Date: July 16, 2001

Subject: **WAVEFORM DISTORTION AFTER
 GAMMA MODIFICATION**

Model: *BVM-D24E1WE*, BVM-D24E1WU
BVM-D32E1WE, BVM-D32E1WU

Figure 2

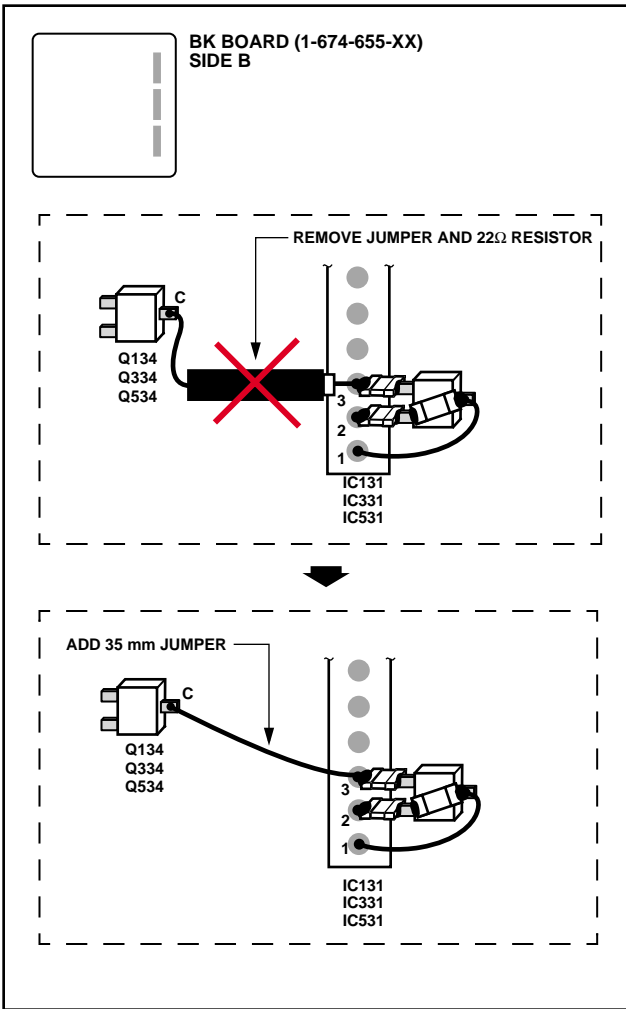
1. Remove three jumper combinations (jumper+22Ω resistor soldered together and covered by UL tubing) soldered between:
 - Collector of Q134 and IC131 pin 3
 - Collector of Q334 and IC331 pin 3
 - Collector of Q534 and IC531 pin 3
2. Solder three new 35 mm jumpers (AWG28) in same locations listed in step 1 above.

Figure 3

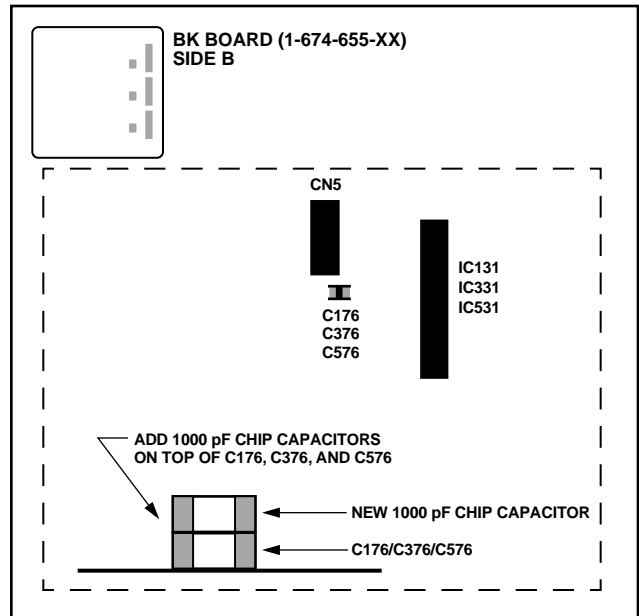
3. Solder new 1000 pF chip capacitors on top of C176, C376, and C576, respectively.

Figure 4

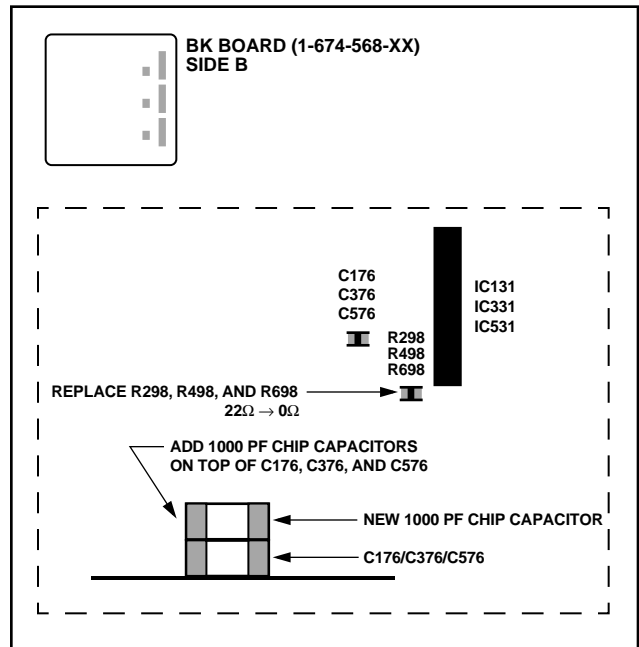
1. Solder new 1000 pF chip capacitors on top of C176, C376, and C576, respectively.
2. Replace R298, R498, and R698 (22Ω) with new 0Ω chip resistors.
